ADDENDUM NO. 3 - OUTLINE AND SUMMARY INFORMATION

Project Name: MSU Molecular Bioscience Building Front Entrance

PPA No.: 22-0045

Date: March 25, 2025

1 Level 1 Electrical Demo Plan
E1D.1
1" = 10'-0"

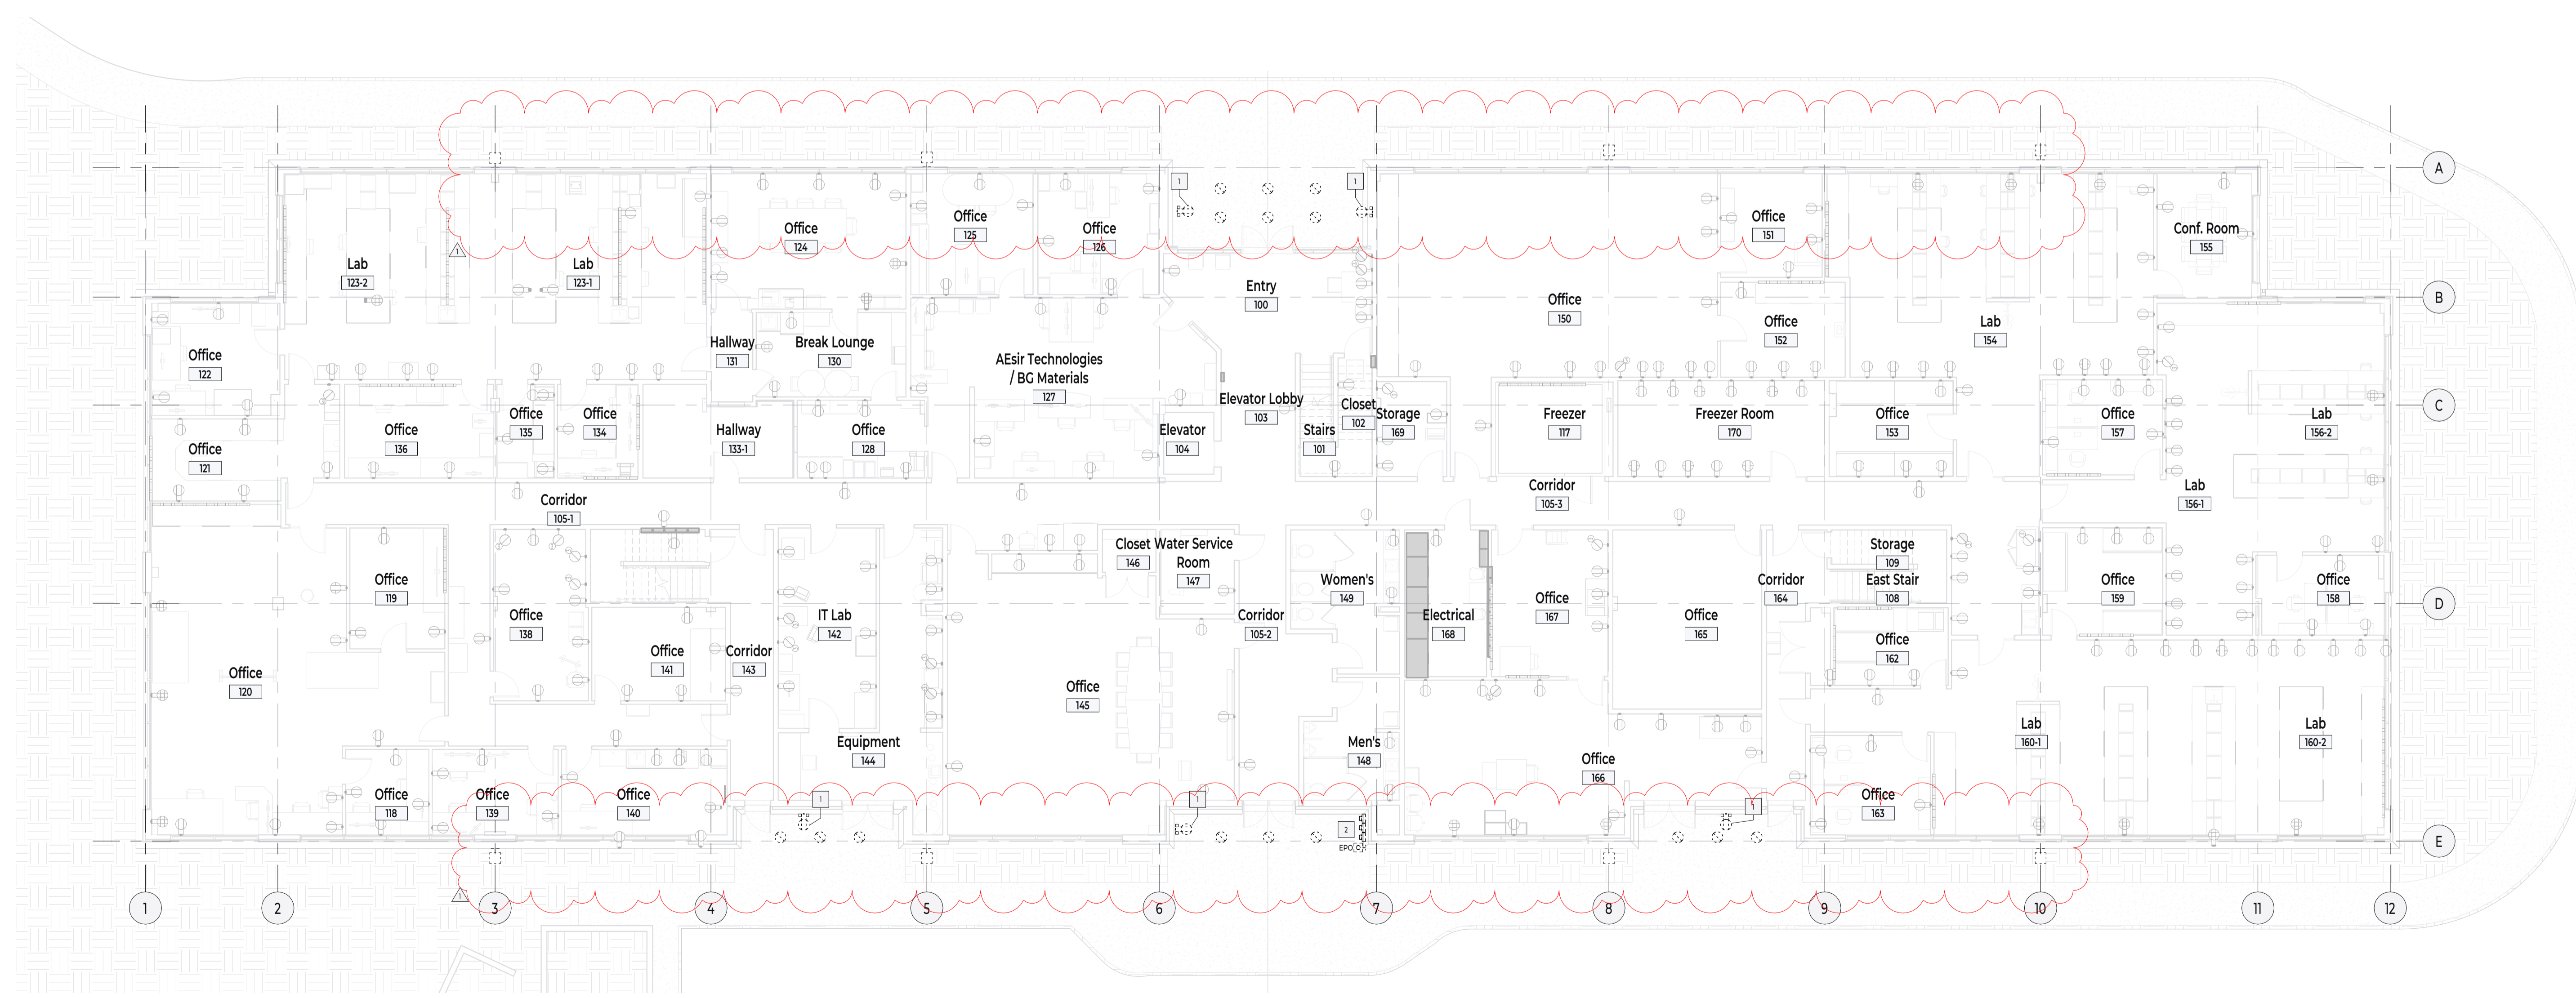
- A. Updates to the exterior lighting on pages E1D.1 and E11.1 as per attached sheets.

1. Remove GFCI receptacle to accommodate architectural demolition. Install new device in this location per E11.1.
2. Remove and reinstall equipment to accommodate new architectural finish.

1 Level 1 Electrical Plan - Phase 1
E11.1
1" = 10'-0"

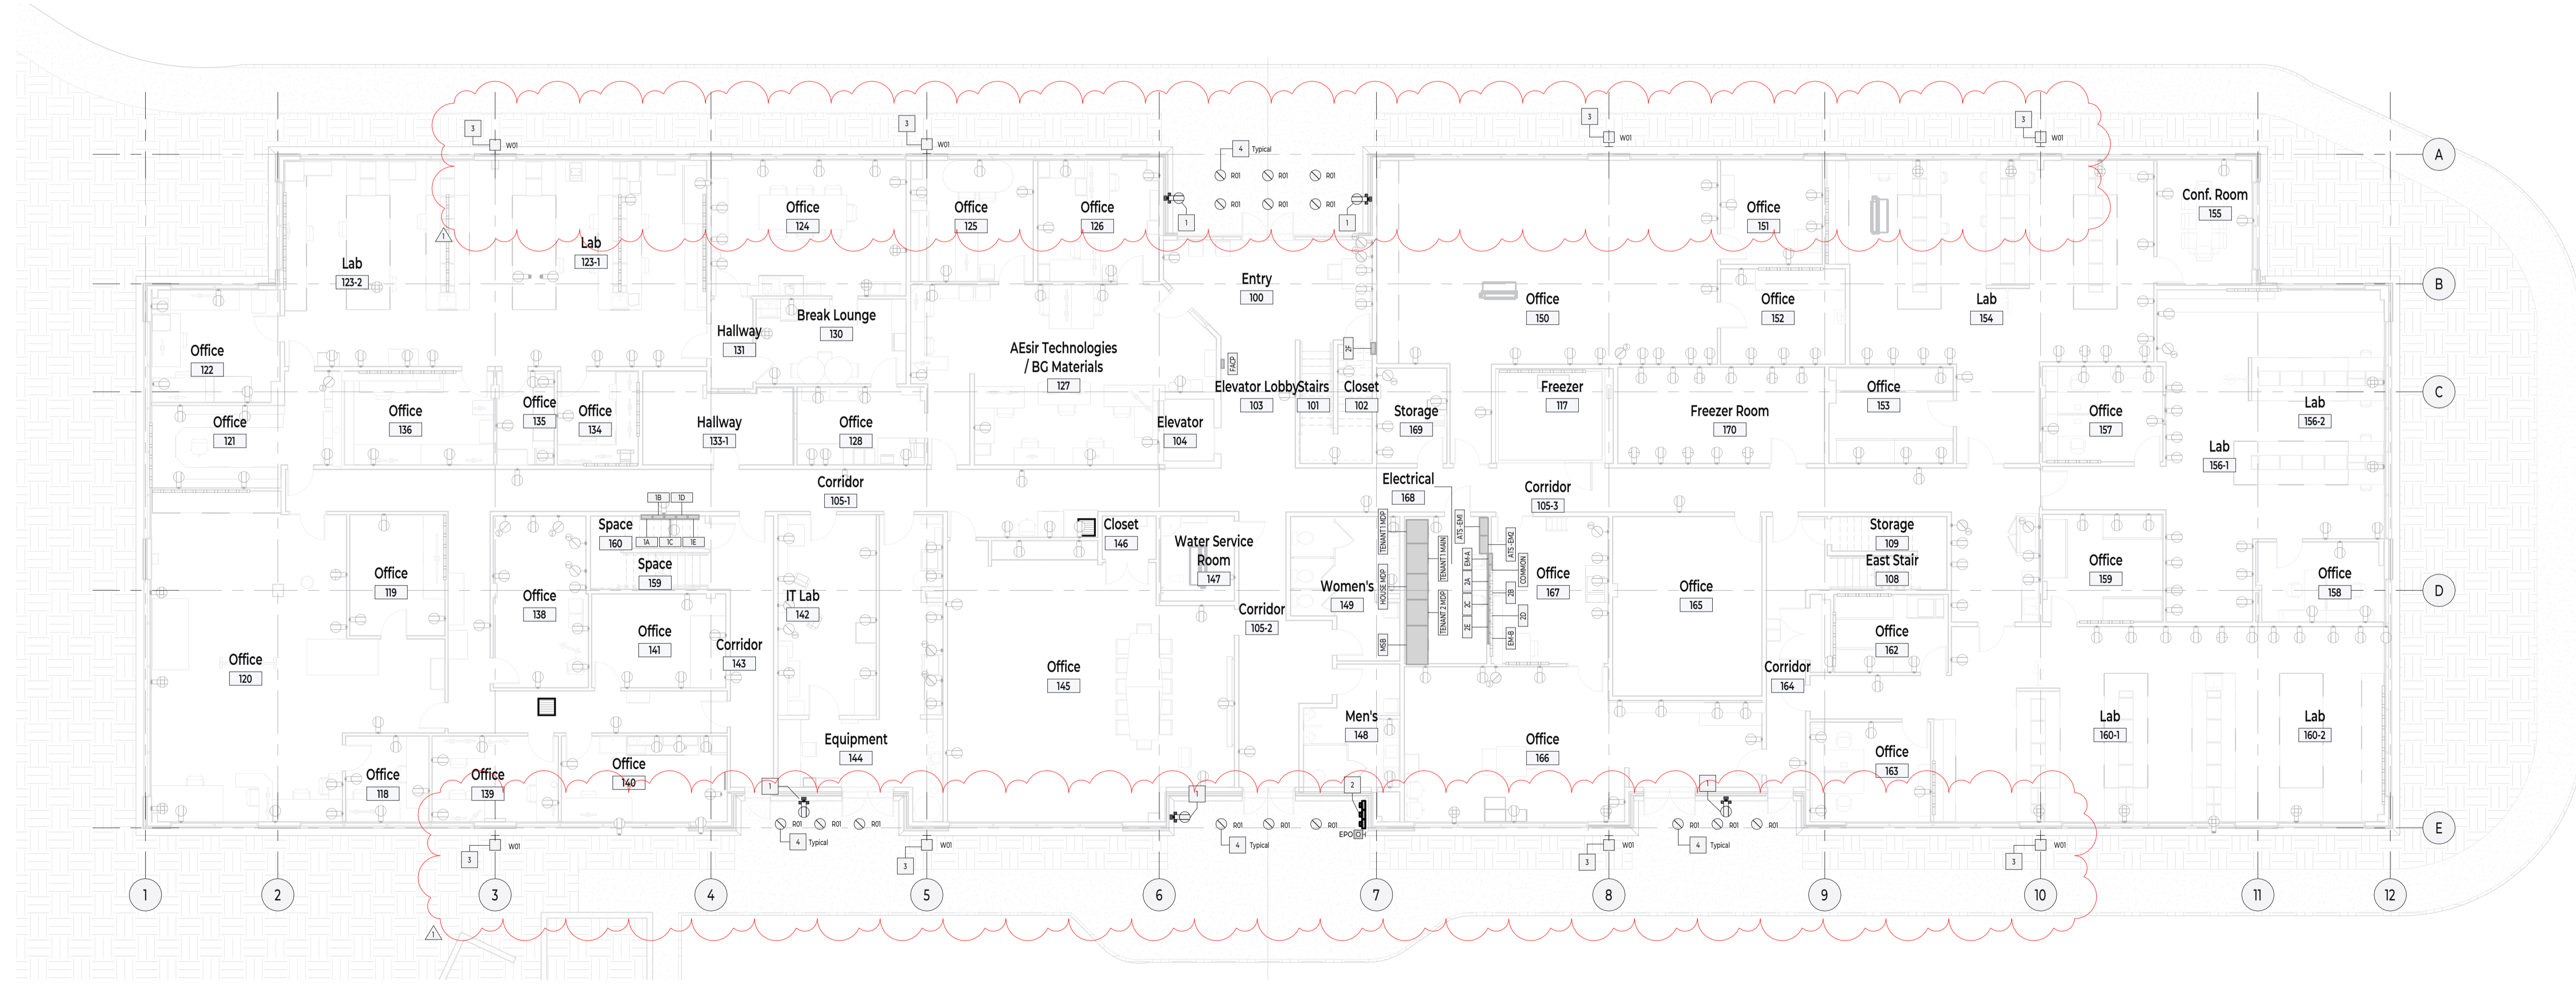
1. New receptacle installed in existing location to accommodate new exterior architectural finish. Provide extension rings or extend raceway as required to accommodate new finish.
2. Reinstall equipment in existing location to accommodate new architectural finish. Provide extension rings or extend raceway as required to accommodate new finish.
3. Connect new wallpack to existing lighting circuit serving this location.
4. Connect new downlight to existing lighting circuit serving this area.
